Transbay Transit Center  
San Francisco, CA  
CM/GC Contract No. 08-04-CMGC-000  
Project No. 30100

**BID PACKAGE TG10.4  
ADDENDUM # 8**

## TG10.4 – Electrical, Communications, Security and Integrated Networks Construction Services

SHEET NUMBER: **SKE-034** SEQUENCE NUMBER: **of**

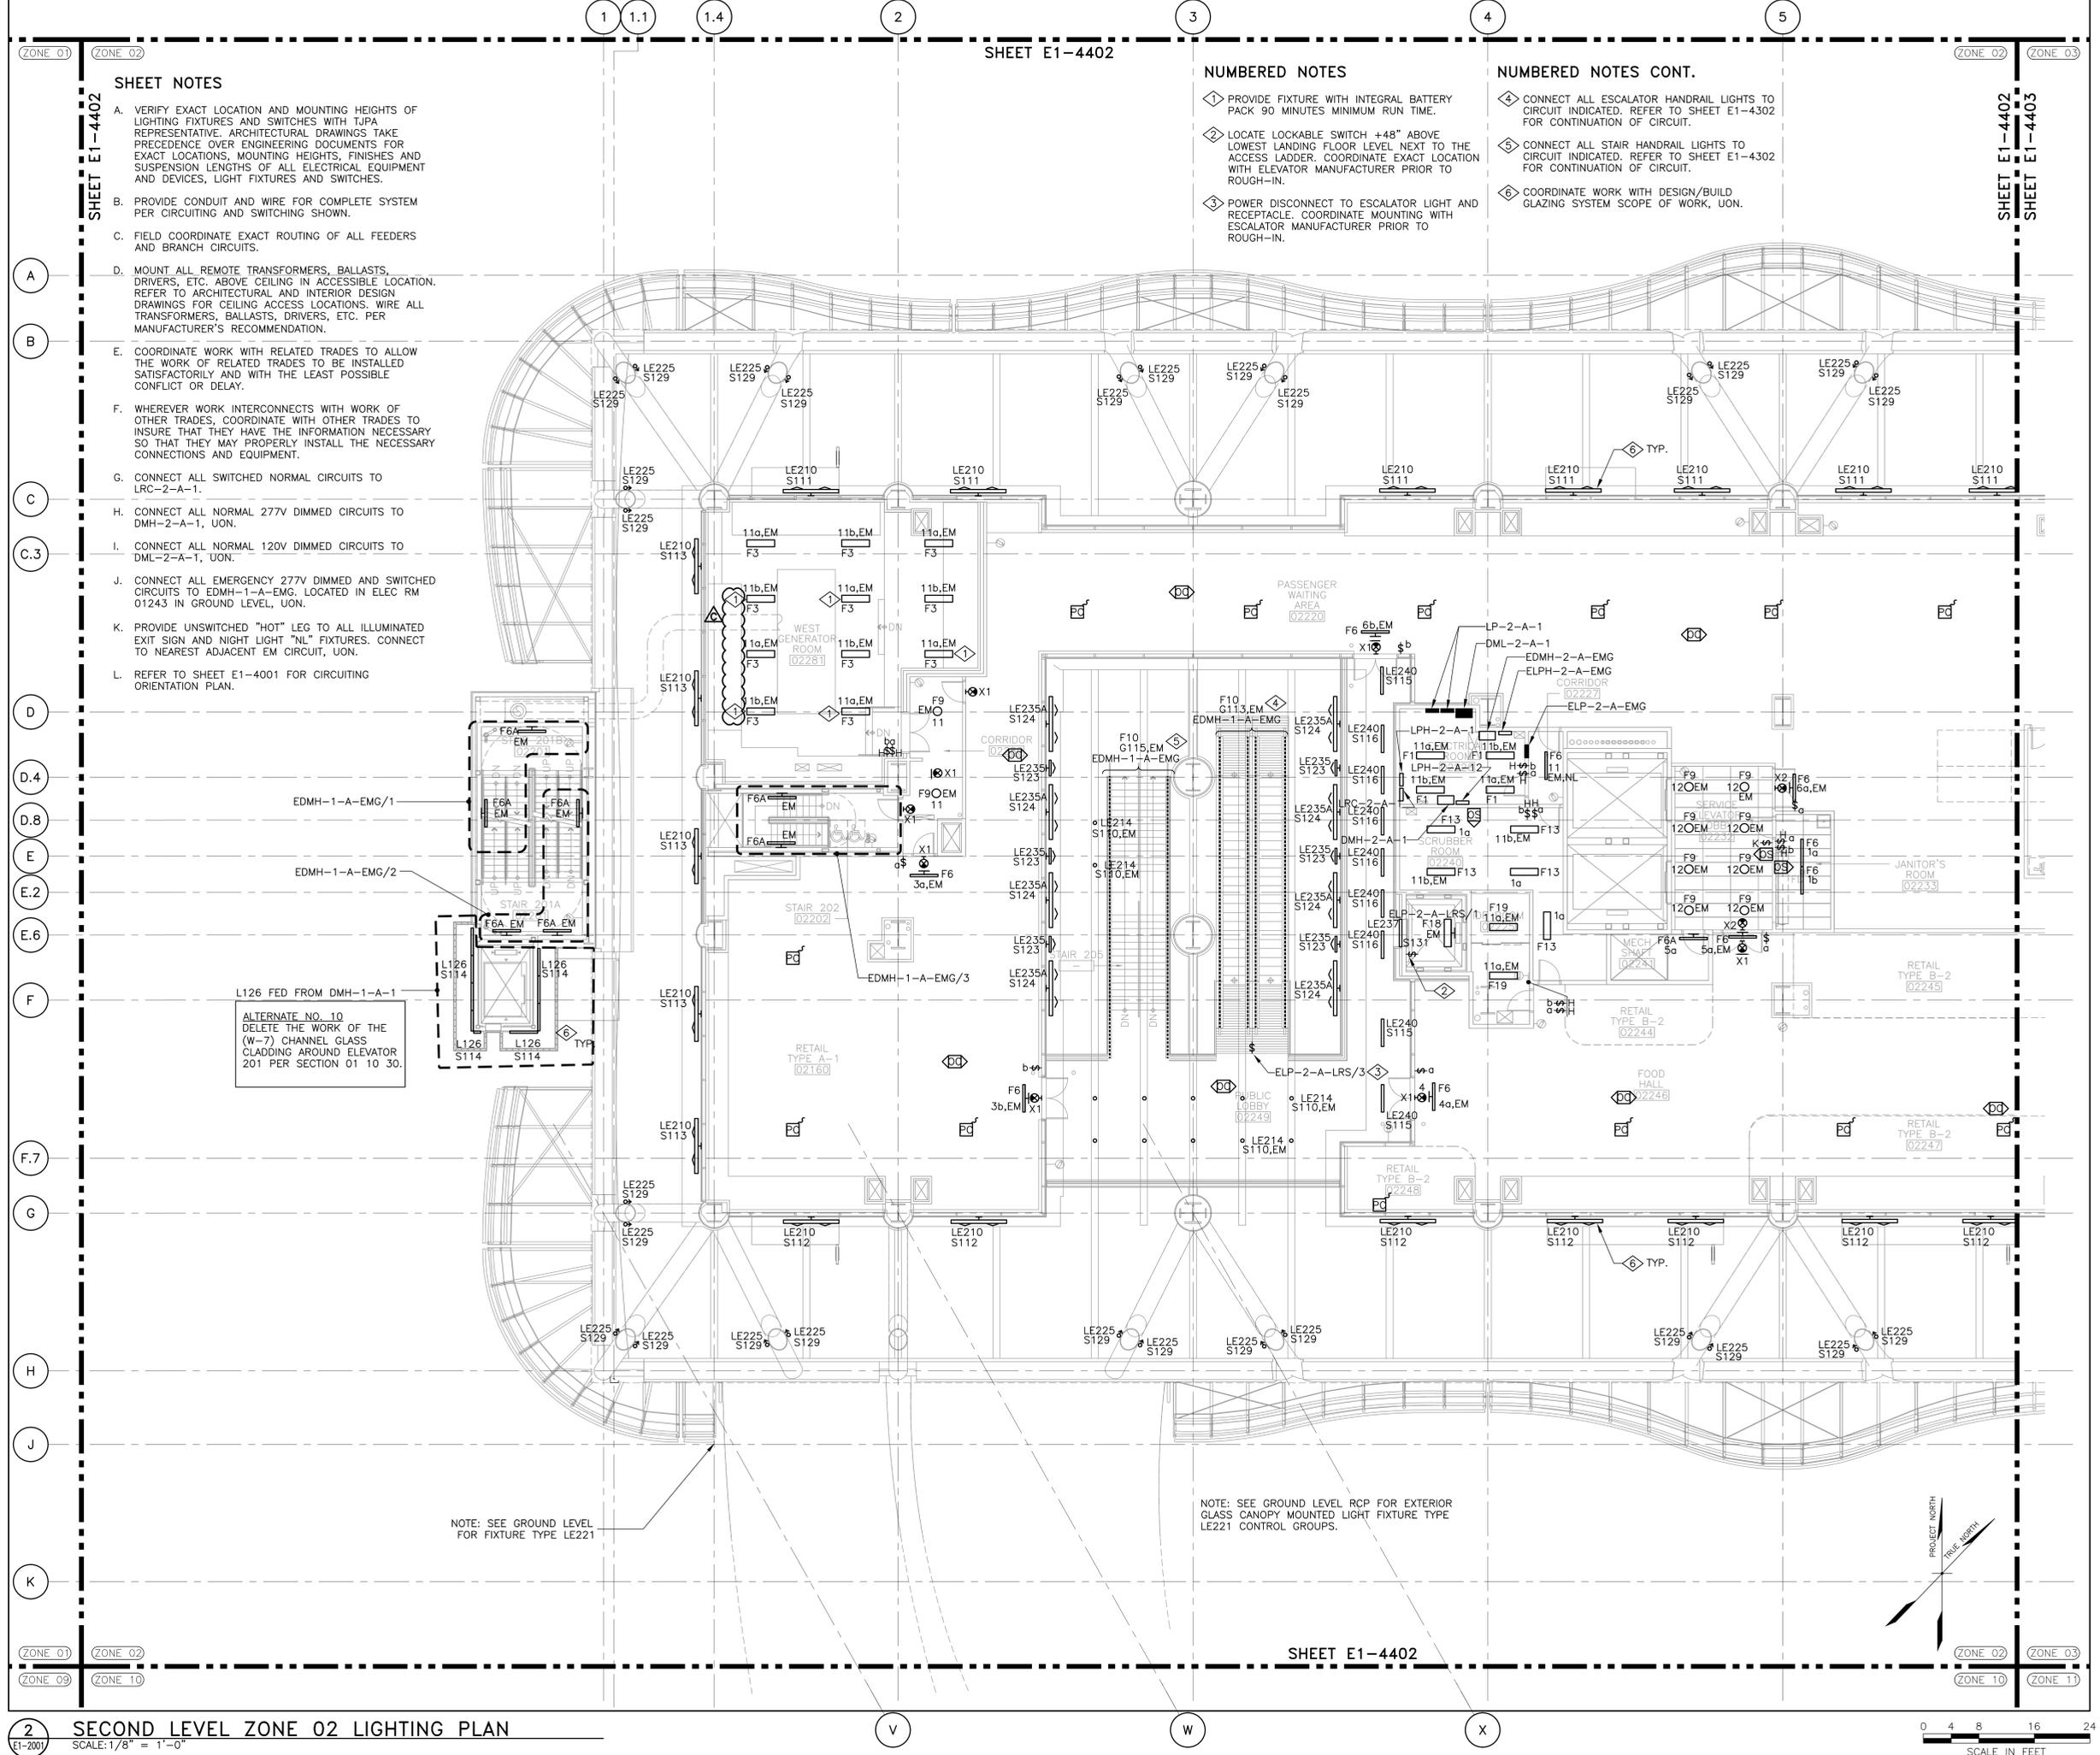
Question No.	Submission Date	Drawing No.	Document/ Spec. No.	Question	Response
TG10.4-048	3/24/2014	E1-4302 Detail(s) 2 (Fixture Type LE211)		Numbered Note 3 on drawing E1-4302 is attached to fixture type LE211. Numbered Note 3 also says that these fixtures are shown for information only. Please confirm fixture type LE211 is shown for information only, and the provision and installation is not to be included in the scope of the electrical contractor.	Fixture LE211 is provided by the TG10.4 Trade Subcontractor. The "for information only" is in reference to a design/build component of the W-1 Glazing System in which the base contract light LE211 is involved. See Specification Section 26 56 00/APA for LE211 fixture data.
TG10.4-049	3/24/2014	E1-4403 Detail 2	26 51 00	Page 07 of Appendix A in Specification Section 26 51 00 states that fixture type L120 is "Not Used." Drawing E1-4403 show three (3) type L120 fixtures in the Public Lobby (Room 02322 at approximate column lines 11.7/E). Please provide information missing in Appendix A so our vendors can price these fixtures.	See attached sketch, SKE-034, for the updated fixture layout.

SHEET E1-4404

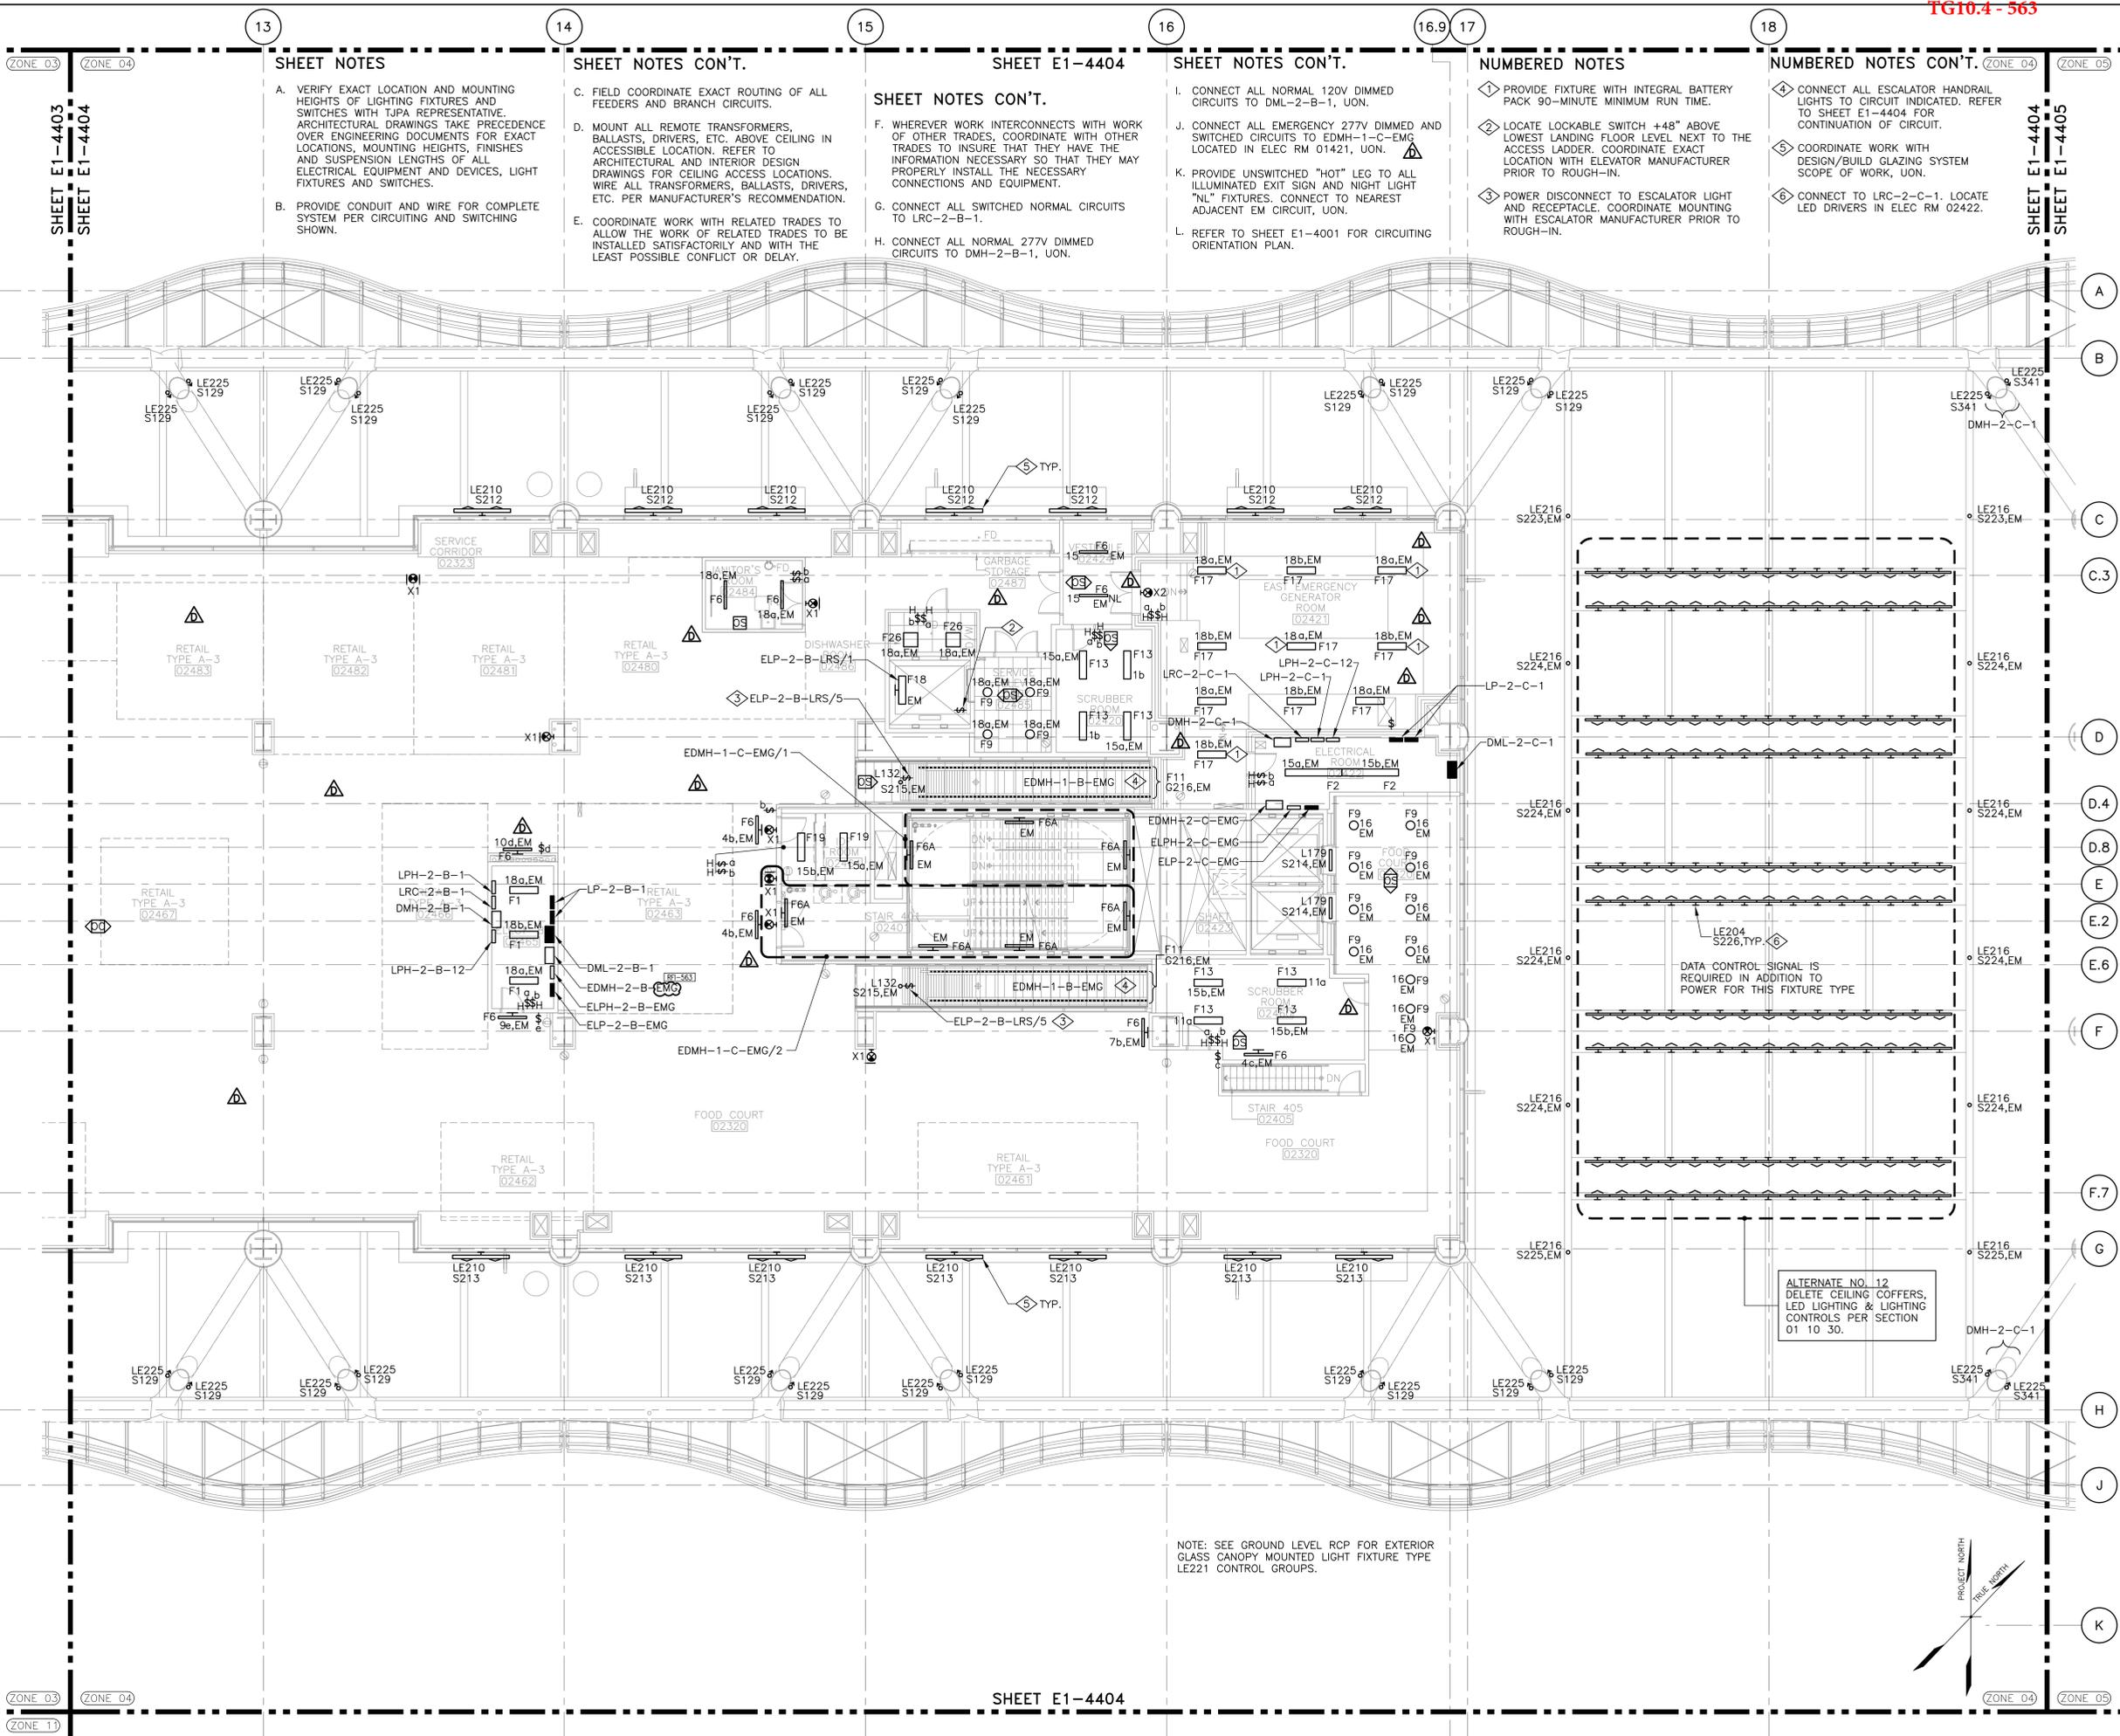
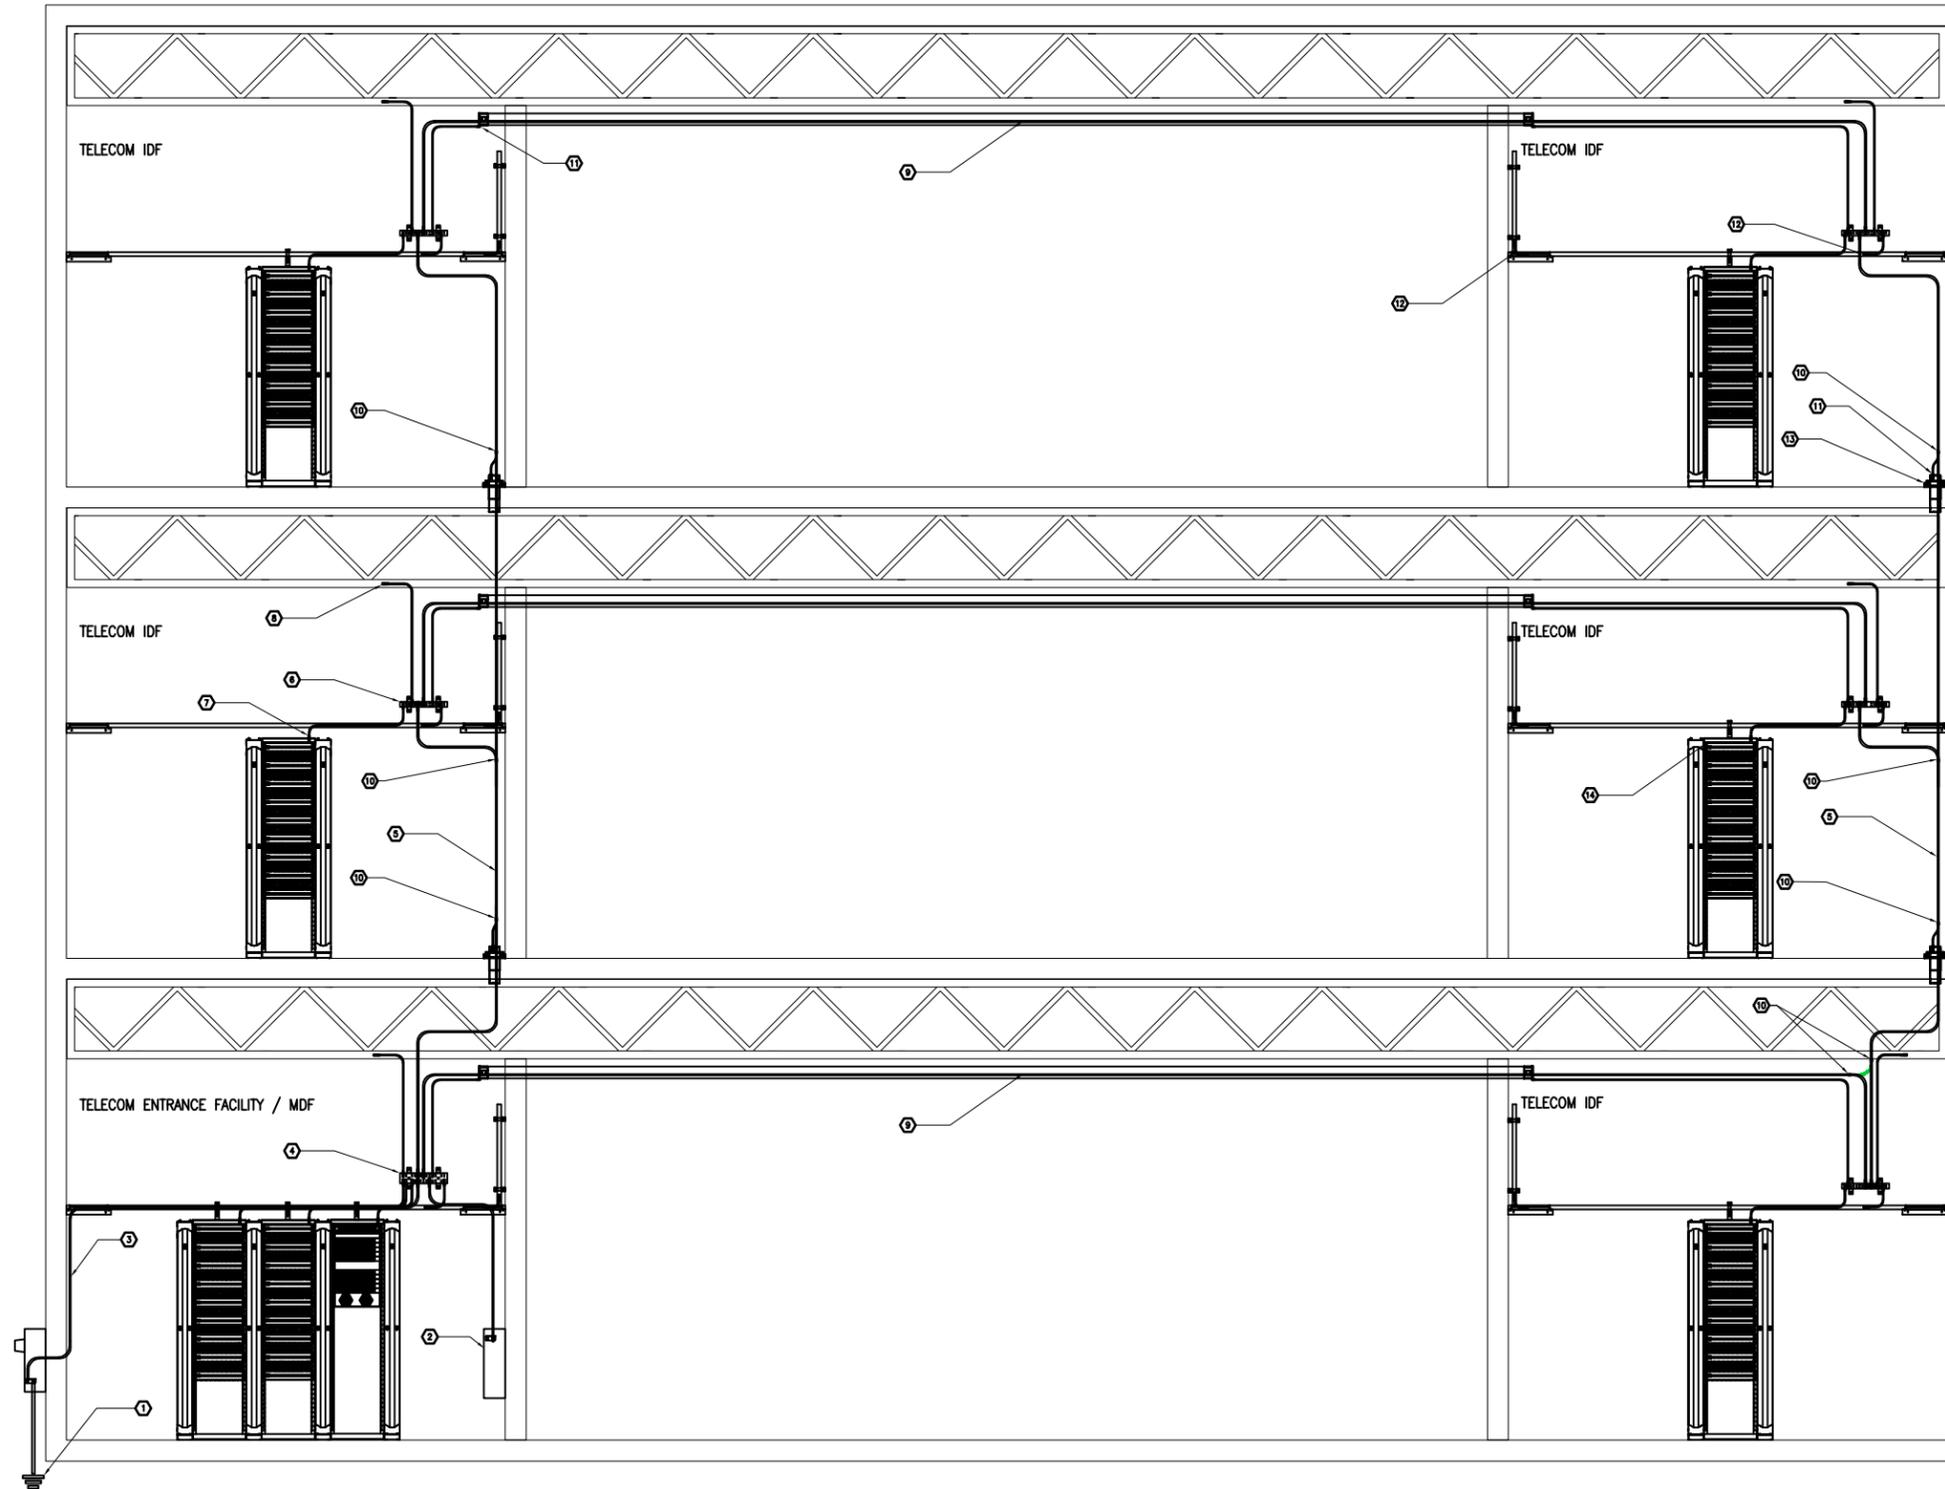
TG10.4-076	4/16/2014	E1-4404 & E1-5302 Detail 1	Location of LRC-2-B-1	The Riser Diagram on drawing E1-5302 shows Lighting Relay Cabinet LRC-2-B-1 on the Ground Level. Plan view drawing E1-4404 shows Lighting Relay Cabinet LRC-2-B-1 located on the Second Level. Please confirm the Riser Diagram on drawing E1-5302 is incorrect.	Confirmed, riser diagram on E1-5302 is incorrect. Riser diagram will be revised in a future addendum.
